PLAN COMMISSION STAFF REPORT

May 20, 2021 - Workshop

Scannell Industrial Development

19501-19701 Harlem Avenue (NEC Vollmer Rd & Harlem Ave)

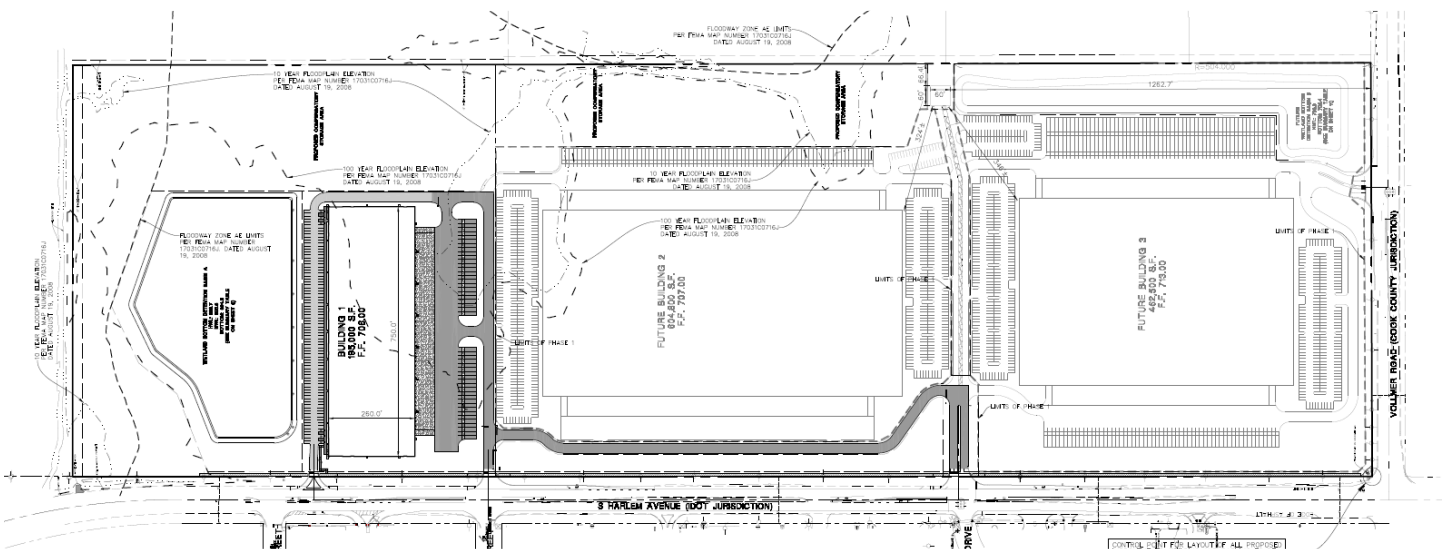
Open Item #2: Discuss and review the overall conceptual site plan and phasing.

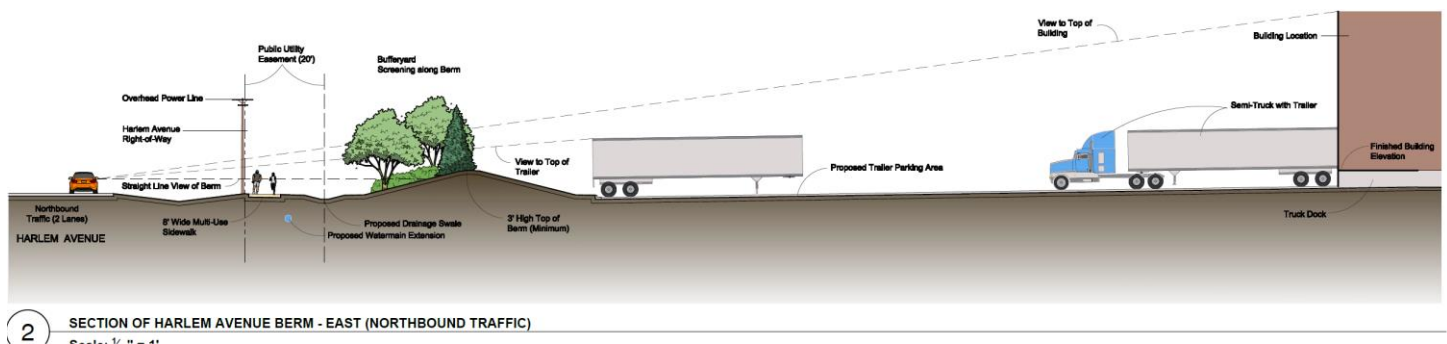
One concern based on the design was the location of truck docks and storage adjacent to Harlem Avenue. While the preference has always been for these items to be located in the rear of buildings, the limited building area and need for cross-docks required them to face the roadway. This specifically happens with buildings 2 and 3. Rotating the building's docks on those to face north and south (similar to building 1) severely limits the overall size of the buildings and the number of docks due to the buildable area of the site. Those alternatives were explored but are not marketable for the developer to potential tenants.

To mitigate the potential views of docks and trailers along Harlem avenue, a landscape berm has been proposed. The berm includes a 3-4 foot high grade increase along with landscaping planted on it. The image above shows a cross-section of how views from Harlem avenue looking towards buildings 2 and 3.

Open Item #3: Discuss the proposed 3'-4' landscape berm buffering the buildings, docks, and trailers from Harlem Avenue.

Above: Existing watermain (blue), required extension for development (purple), and additional extension to create water system loop (red).

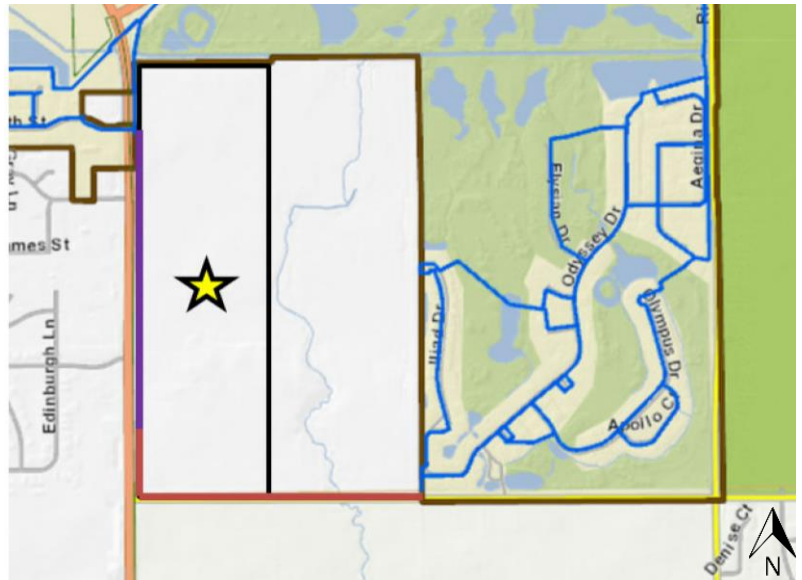
To complete the watermain loop, the developer will need to extend the watermain much further than their development requires down Vollmer Road (shown as the red line on the image above). The developer has agreed to complete this work with their project to create the benefit to their development and the larger community. Any cost reimbursement for watermain beyond their development's requirements will be covered within the Annexation Agreement. The watermain work will be completed with Phase 1 of the project. In addition to water, other utilities such as sanitary and storm sewer will be run to the sites but phased with the development since they are not as crucial to public safety. The location of the utilities will be located on the private site within a utility easement based on the preference of the Public Works Department to not have the utilities in IDOT right-of-way.

Open Item #4: Discuss proposed watermain extension and utility improvements.

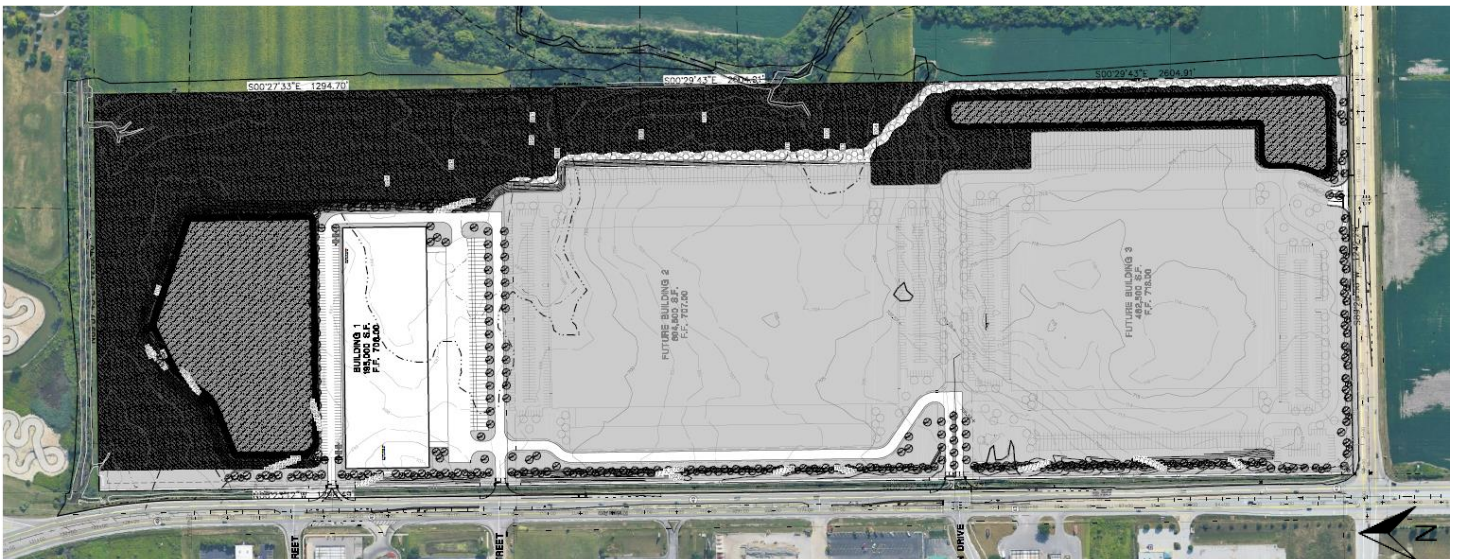
As part of phase 1, there will be the construction of the turning lane at the signalized access at Benton drive and the roadway connecting building 1. That roadway serves primarily as a truck access between the three sites. Additionally, the two Harlem Avenue right-in/right-out driveways will be constructed pending IDOT approval. Lastly, work at the Vollmer Road lighted entrance will be completed so that it is installed from the beginning (with Amazon's improvements) and doesn't need to be modified later. However, while the work is going to be completed, that intersection will not be connected by roadway to building 1. The work to be completed as part of phase 1 is shown in white below while the light gray indicates the pad that will be left for future phases and final approvals.

Open Item #5: Discuss circulation within and external to the site overall and proposed with Phase 1.

Building 1 Final

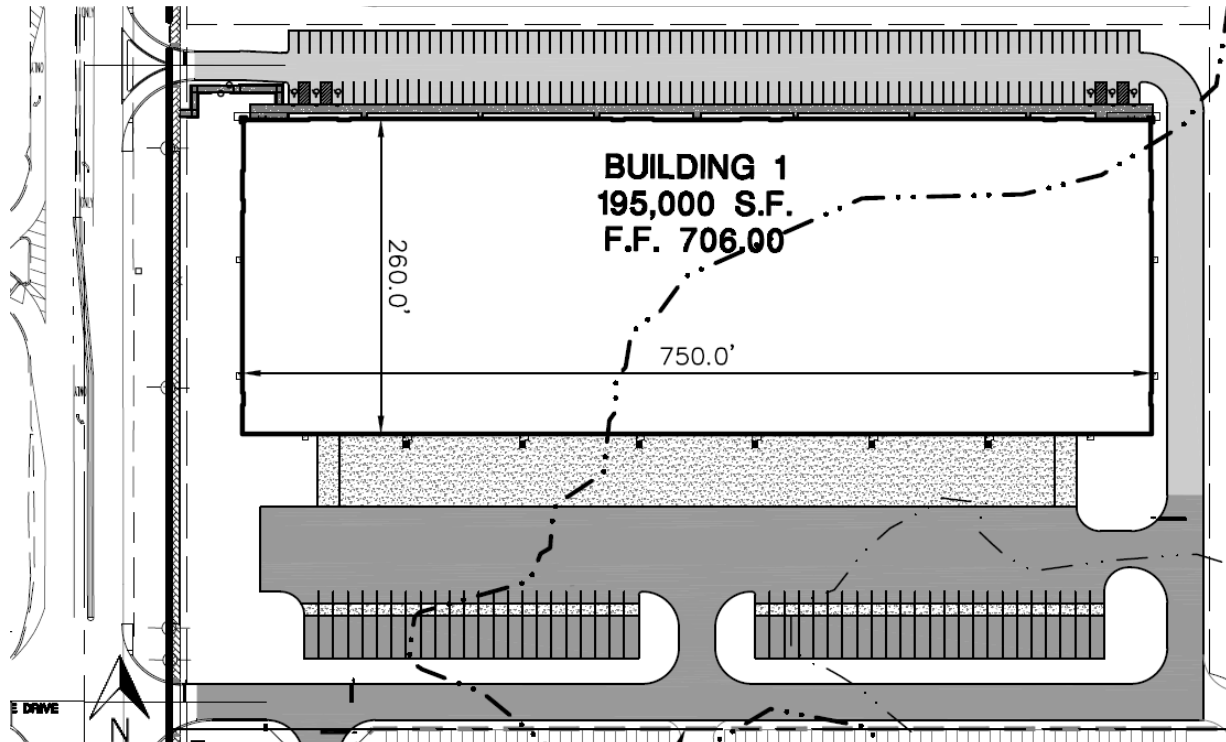
As part of Phase 1, final approval is being given to the building 1 site. The site includes an approximately 195,000 sq. ft. building, 125 parking spaces on the north side of the building, 24 docks and 50 trailer storage locations on the south side of the building. The site will tie into the internal roadway system and will have access to three access points including the signalized intersection at Benton Drive that will be constructed with phase 1. The building is setback 63' 9" from the Harlem avenue right-of-way line. In that setback will include the 3-4' high landscape berm to help block views of the docks and trailer storage. All garbage will be kept internal to the building and placed outside on pickup days only.

Open Item #6: Discuss the final site plan approval for Building 1.Engineering

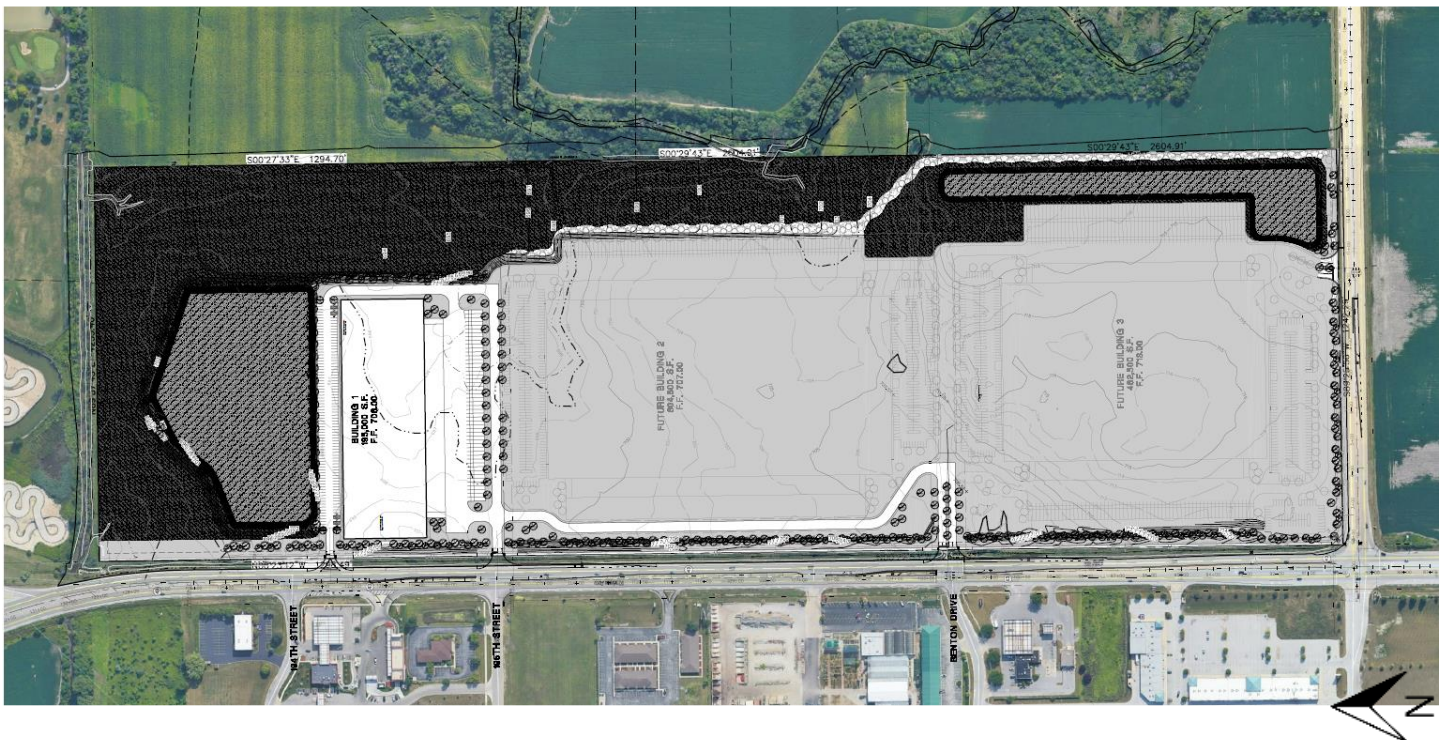
Landscaping internal to the site is proposed at the development's various entrance/exits, lining internal drive aisles and with the placement of landscape islands within employee/visitor parking lots. Landscaping is not proposed in loading dock or storage areas as landscaping/curbs and large trucks trying to maneuver through the sites do not mix well. The final Phase 1 approval includes all landscaping shown below including the buffers along Harlem Avenue and Vollmer Road, the driveway entrances, and around the internal drive aisles and parking lots associated with building 1. Additionally, the detention ponds will be constructed to include native wetland prairie grass that allow for an attractive open space and helps to filter stormwater without needing excessive pesticides. The natively planted open space and detention ponds are expected to blend into the surrounding golf course and the adjacent undeveloped land to the east (with the creek).

Open Item #9: Review overall Landscape Plan including overall bufferyard proposals and final approval for Phase/Building 1.

Building 1 – Final Approval

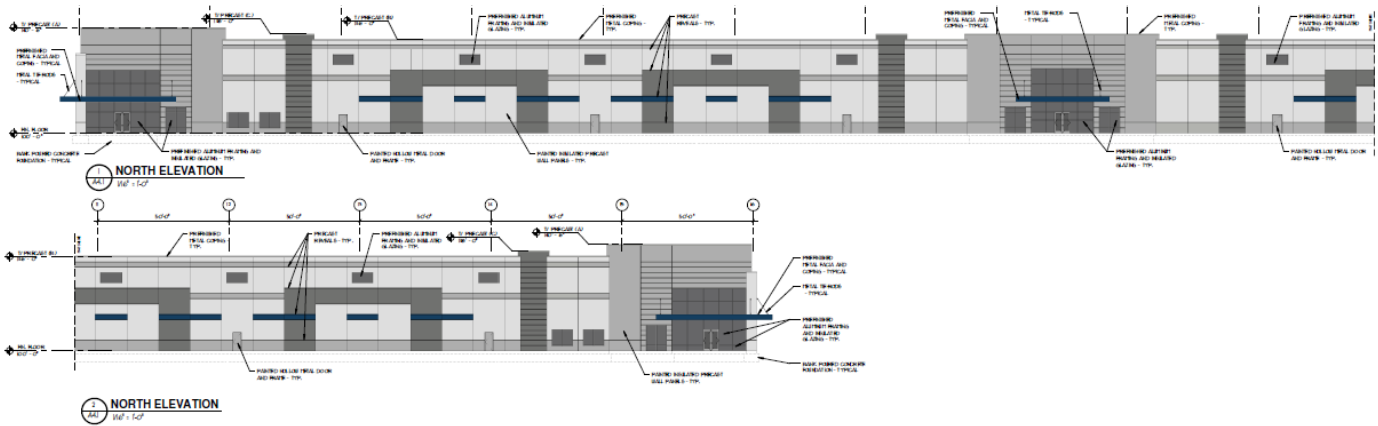
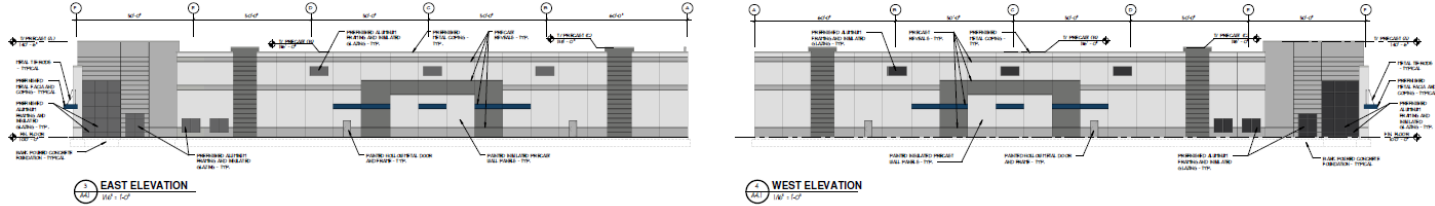
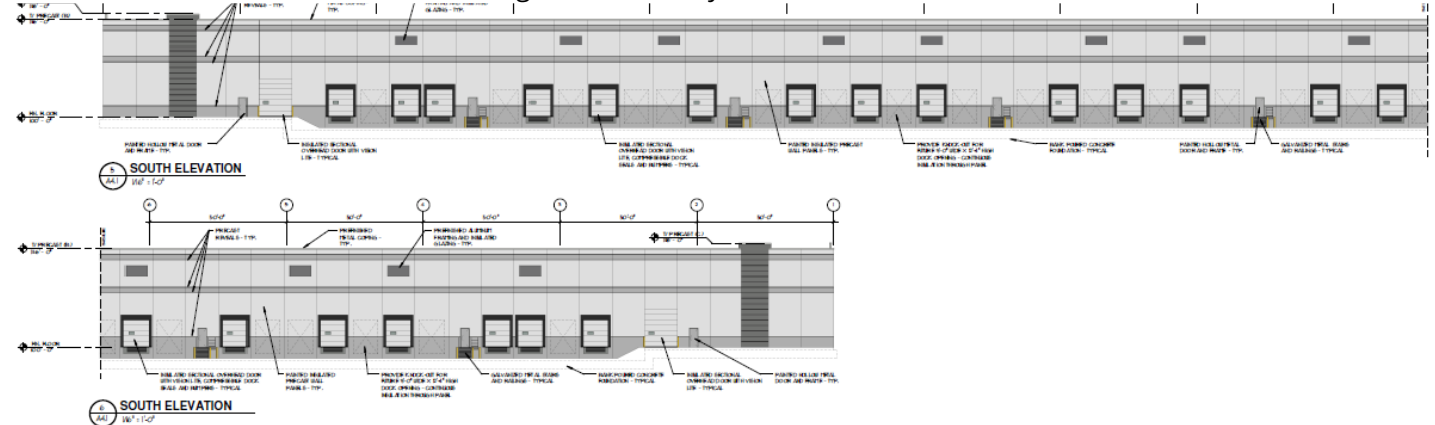
The building will be largely constructed of precast concrete panels. There are three glass architectural elements to anchor the building's two corners and the center for the north/front façade that will be most visible to Harlem Avenue. While the total number of tenants and internal layout will be determined based on the tenants chosen, this provides a natural space for up to three main entrances for employees. Canopies have also been placed over the entrance points to draw attention to them as customer or employee entrances. Overall there is articulation in the buildings appearance and roof line that makes it look attractive and not "boxy". The rooftop parapet has been designed to screen all rooftop equipment from view of the street.

The rear/south side of the of the building is where the dock location has been proposed.. However, the common architectural design elements have been carried through to this side. Due to the unknown needs of the future tenants,, some of the docks have been proposed to be installed while other locations will have “knock-out” areas where docks doors can be added or enlarged if needed by the future tenants.

Open Item #11: Review and discuss the proposed architecture of building 1 and need for any overall development standards.
